EFRA ANNUAL SECTION MEETING

7-8th of November 2026

AGENDA ELECTRIC SECTIONS - GENERAL.

Appendix 3 A

Current Rule – 7.2.1

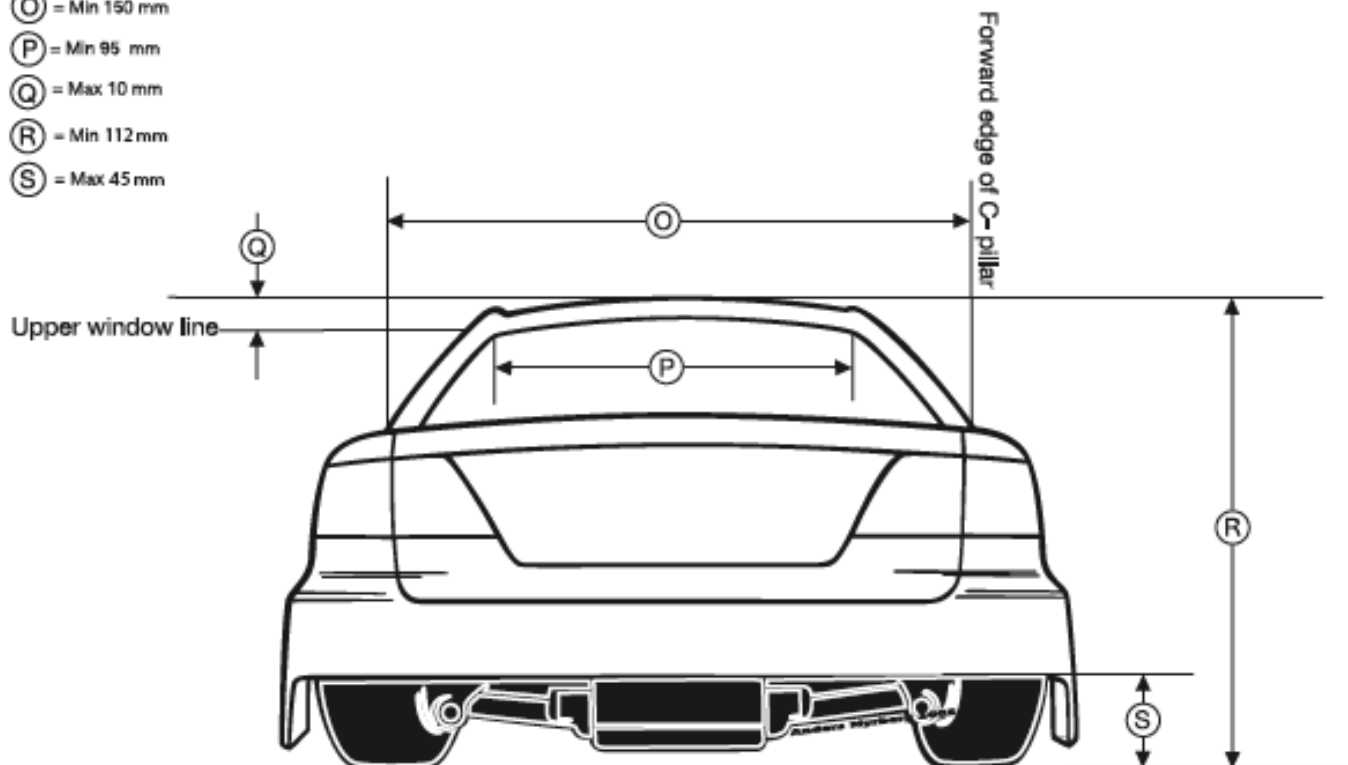
Proposal to amend or change this rule

Figure 1:

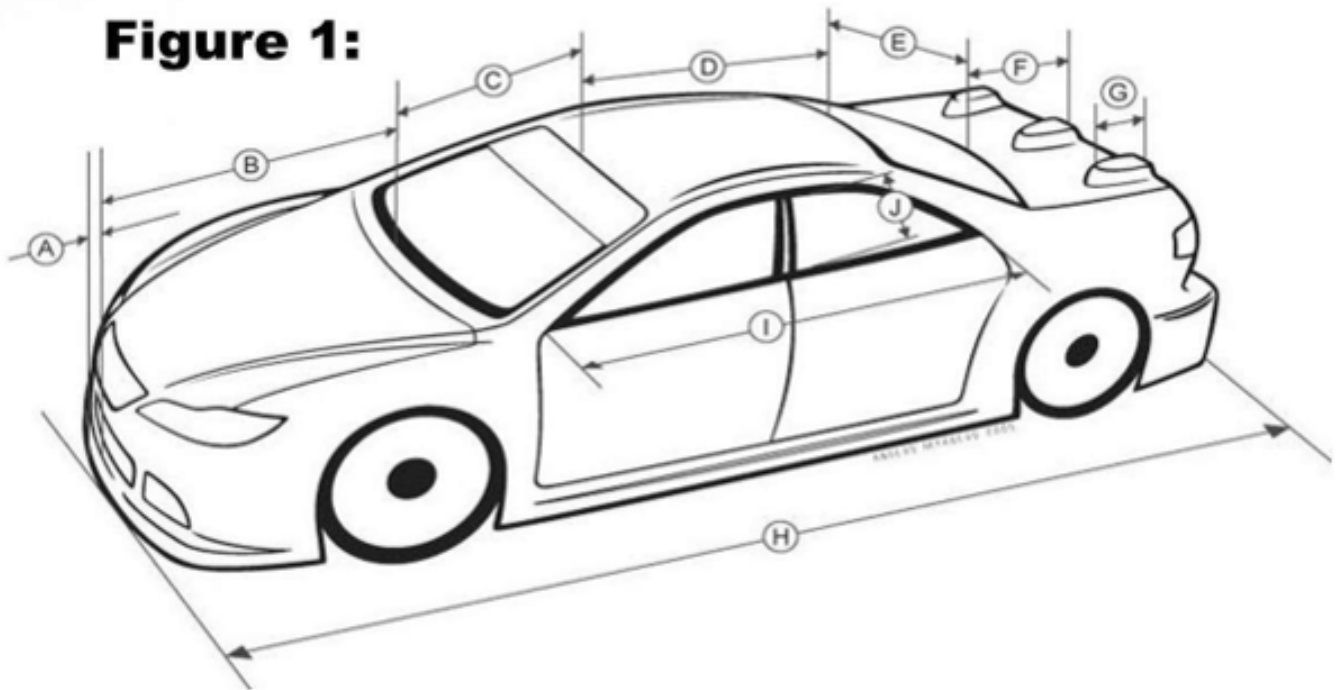
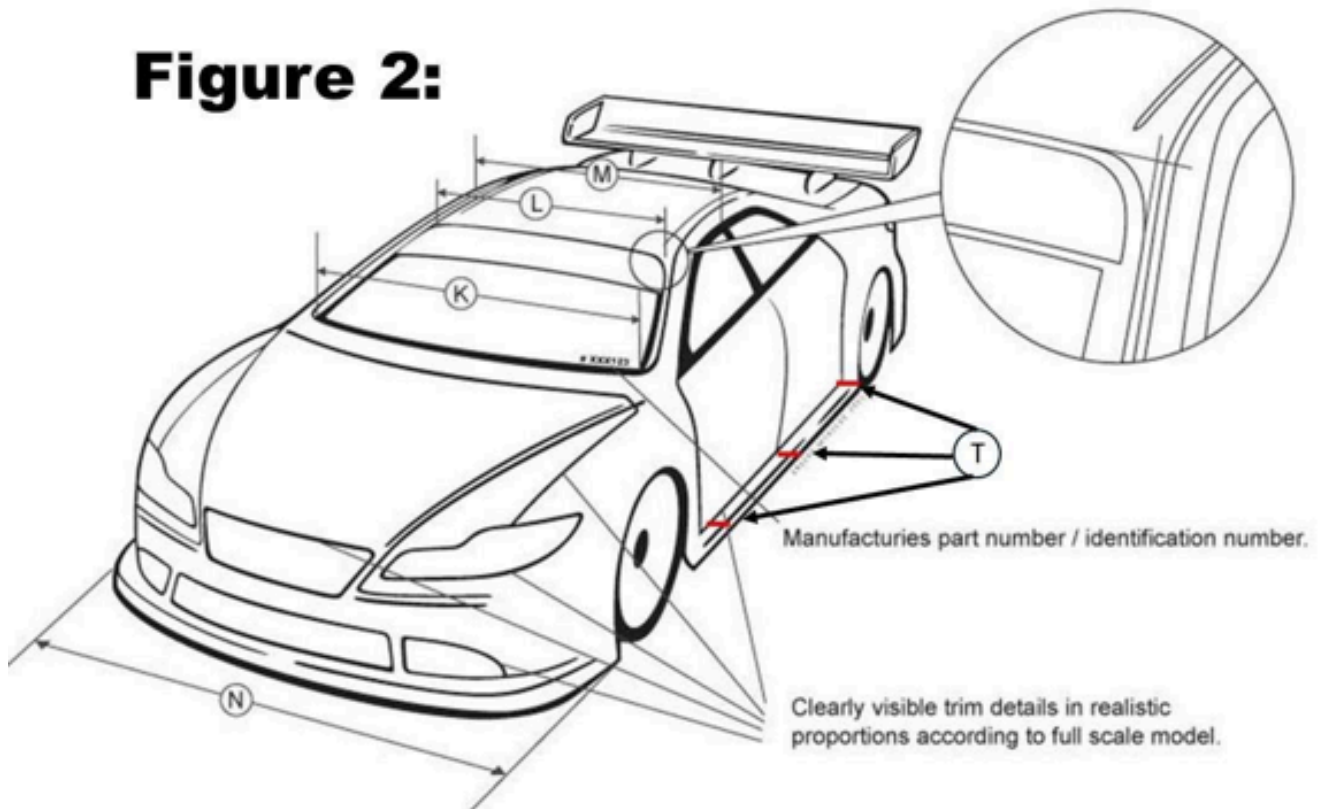
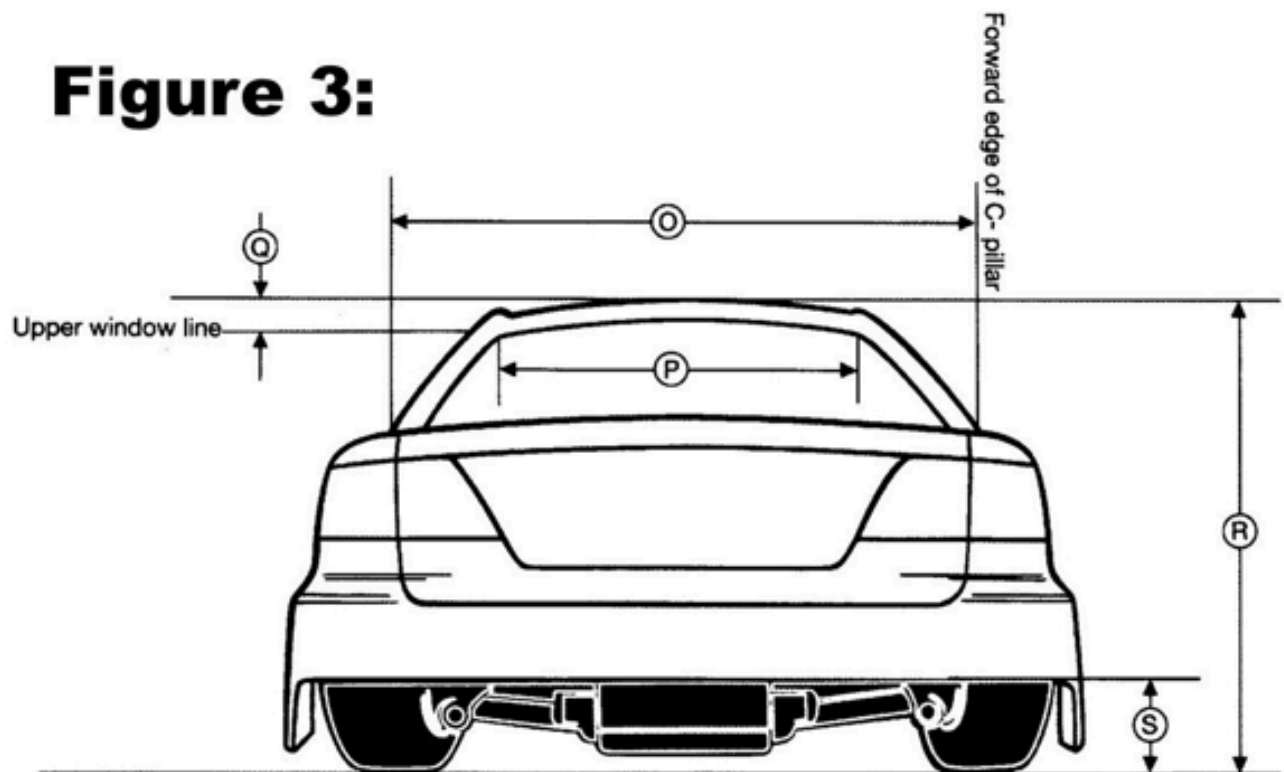
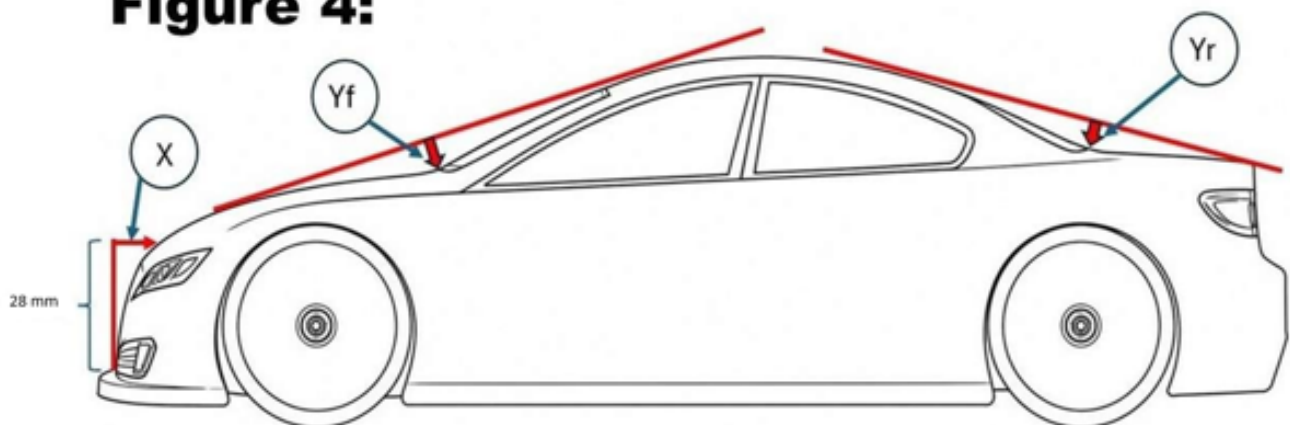
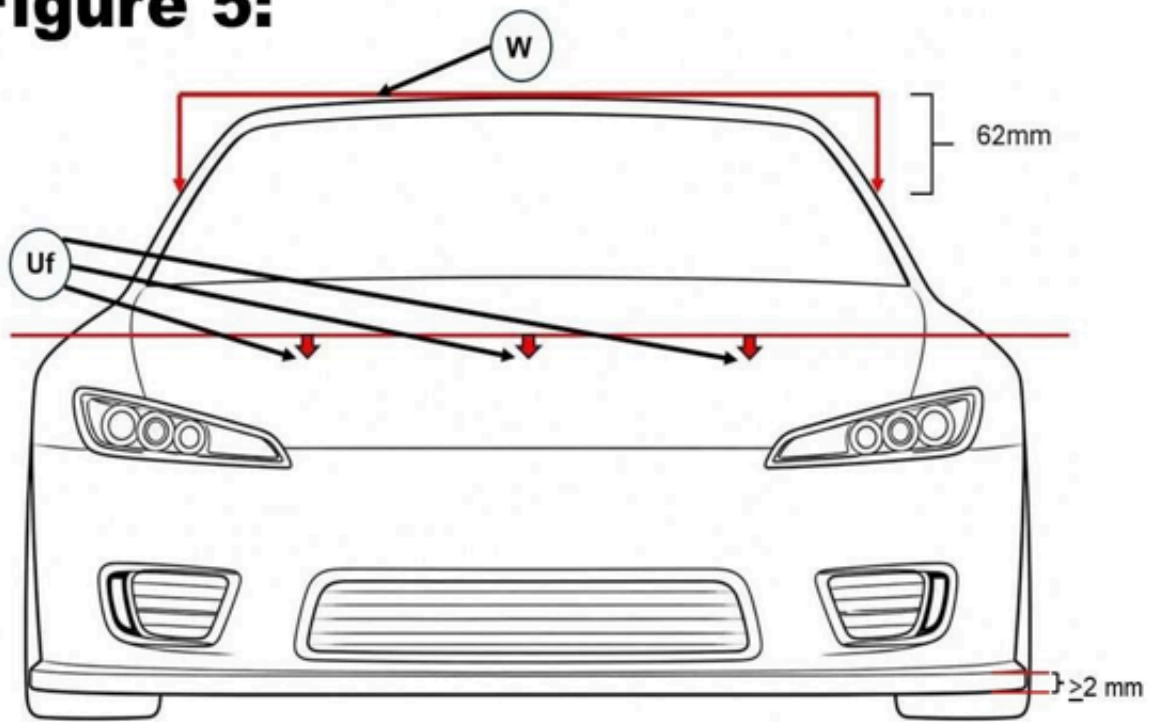
Proposal to amend or change this rule

R	Roof Height with Chassis on 10mm blocks	117mm	---	Fig. 3
S	Rear Bumper Height with chassis on 10mm blocks	---	50mm	Fig. 3
T	Insert Depth of L&R Side Rocker Panels	---	10mm	Fig. 2
U(f)	L&R Fender Height Above Primary Hood Surface	---	8mm	Fig. 5
U(r)	L&R Fender Height Above Primary Trunk Surface	---	3mm	Fig. 5
V	Roof Rail Height (inside depth from top to bottom)	---	5mm	n/a
W	Width between L&R Side <u>Windows</u> (@ 62mm below highest center point of roof)	173mm	---	Fig. 5
X	Distance to Front Hood from a Point 28mm directly Above the Top Inside Edge of Front Splitter	---	22mm	Fig. 4
Y(f)	<u>Transi on Depth</u> : Front Hood to Front Roof	4mm	8mm	Fig. 4
Y(r)	<u>Transi on Depth</u> : Rear Roof to Rear Splitter	13mm	18mm	Fig. 4
Z	Wing Setback: Distance from Trailing Edge of Spoiler to Back Edge of Wing Mounts	---	13mm	n/a
